PUBLIC UTILITIES COMMISSION

RE: Minor Project Refinement #15 for the Fulton-Fitch Mountain Reconductoring Project

MINOR PROJECT REFINEMENT REVIEW FORM

Figure 1: Map of Proposed Activities – Access Route and Work Area

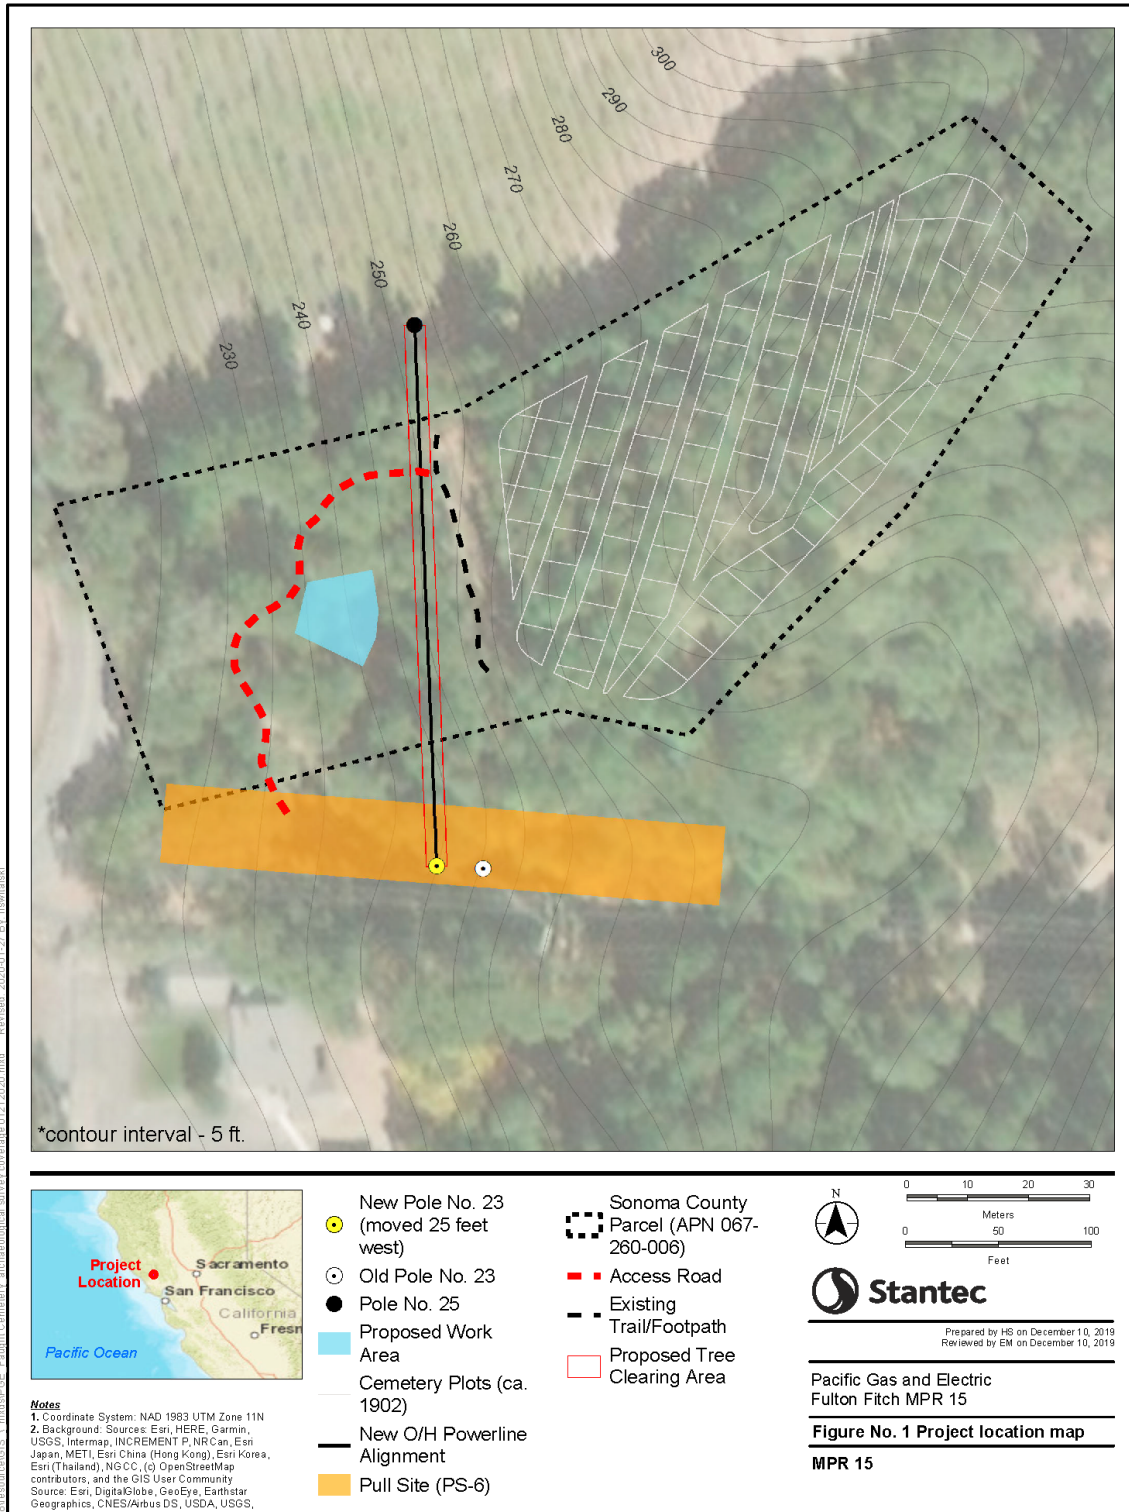
- All vehicle and equipment access will be limited to the proposed access road, work areas, and vegetation removal area identified on Figure 1.
- No vehicle or equipment access would occur within the Historic Burial Area identified on Figure 1.
- The western boundary of the Historic Burial Area and the additional outlying site identified in the canine survey will be clearly delineated and marked with stakes and flagging by a qualified archeologist for avoidance.
- Trees will be limbed and directionally felled away from the avoidance areas.
- Vegetation crews will receive preconstruction training regarding the boundaries of the avoidance areas and the necessity for the implementation of required avoidance mechanisms.
- An environmental monitor will be present to ensure avoidance and implementation of prescribed vegetation removal methods.
